SUNLIGHT HOUSE
LISTED BUILDING CONSENT
CENTRAL OFFICE BULKHEADS

Date: 21/09/2024
Revised: 06/11/2024
Planning Ref: 136161/LO/2023

Office Bulkheads

PROPOSAL FOR THE EXTENSION

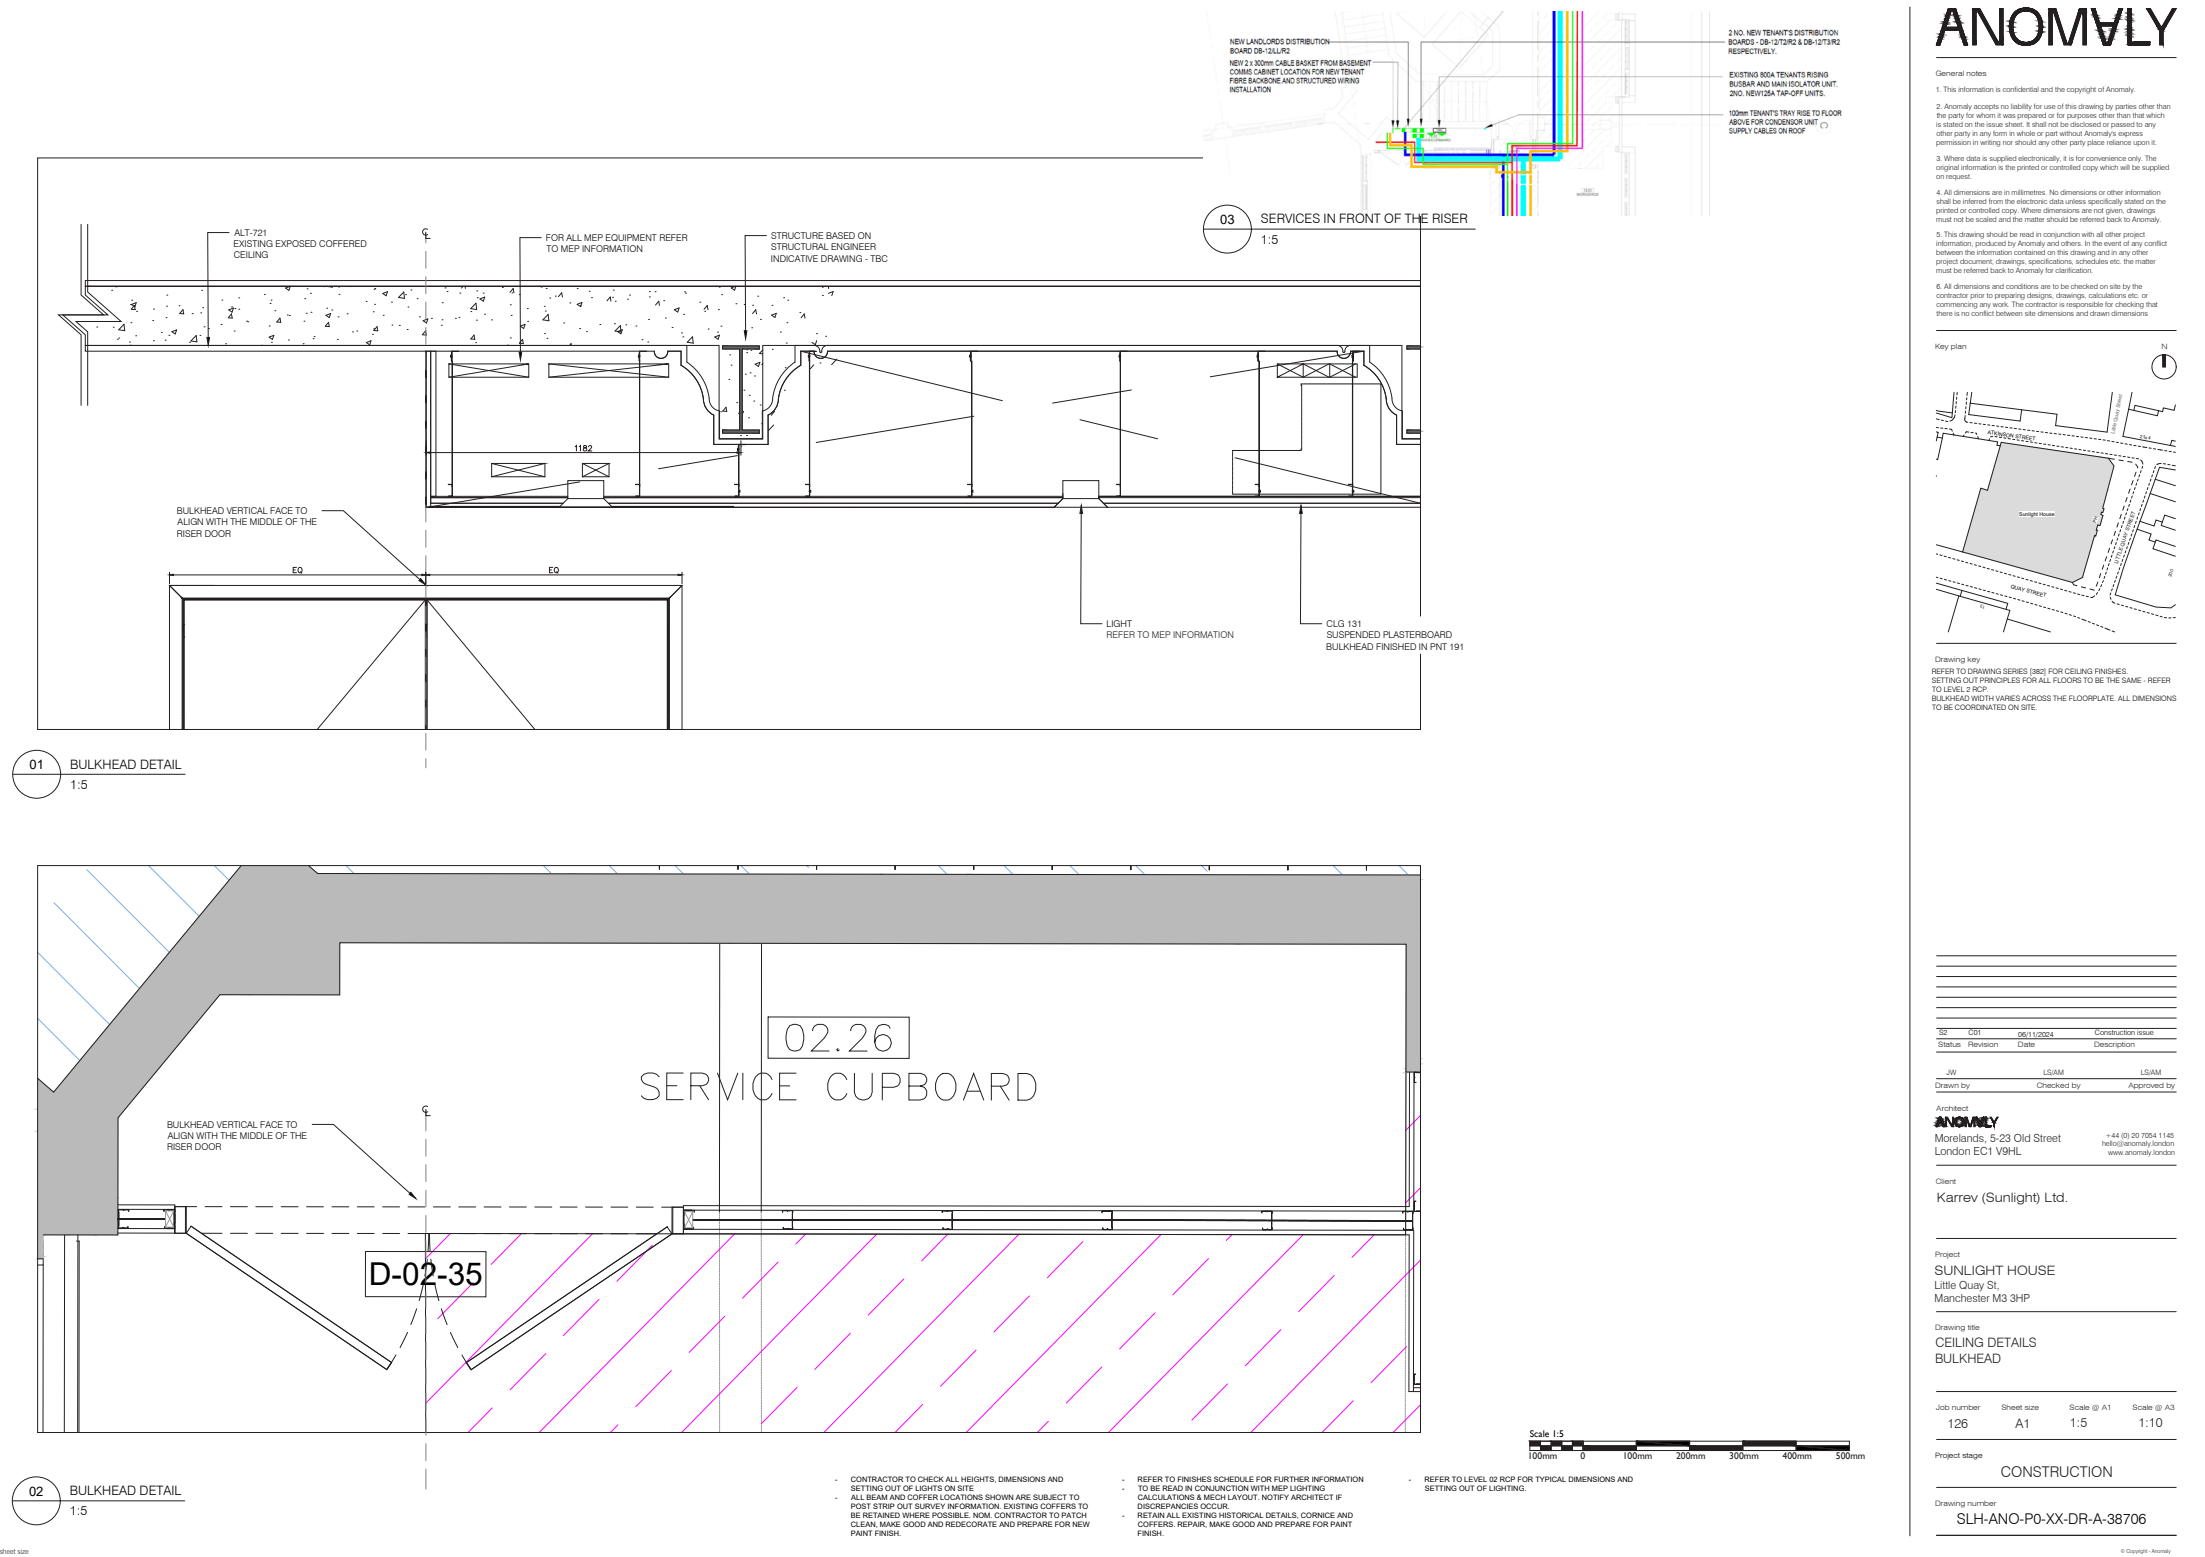
(in front of the riser)

It is now proposed to ommit this on-floor cupboard.

riser. The original intention was for the high level penetrations to feed from the riser to the bulkhead to the right of the proposed extension. There is a 1.6m wide vertical tray which goes floor to ceiling on all floors.

bulkhead will finish in the middle of the new riser double door.
